City of Portland, Oregon
Bureau of Development Services
Land Use Services
FROM CONCEPT TO CONSTRUCTION

Re: Land Use Review LU 24-041109 CU EN GW

SUBJECT: LU 24-041109 CU EN GW Portland General Electric
Harborton Reliability Project incompleteness review

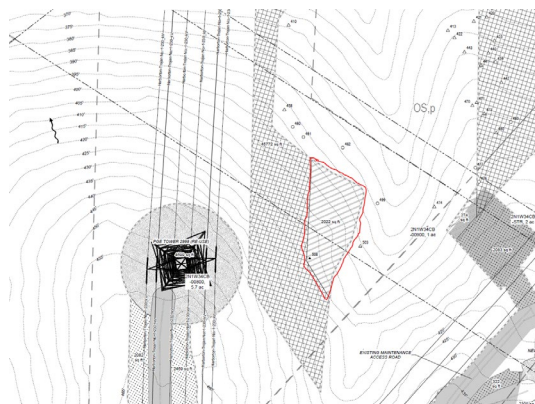
- i. Square footage of wetland impacts both at Harborton Substation and Forest Park (Wetlands A and B) should be noted in a table and included on the plans.
- ii. Tree 994 (51-inch DBH Oregon white oak) and Tree 80 (34-inch DBH Oak) are proposed for removal for proposed access; however, it appears to be adjacent to an already disturbed/cleared area. Provide information on why these substantial trees are proposed for removal and what alternatives were

explored for access in this area that would allow these trees to remain. Further, it appears these trees are outside existing easements on City of Portland owned property.
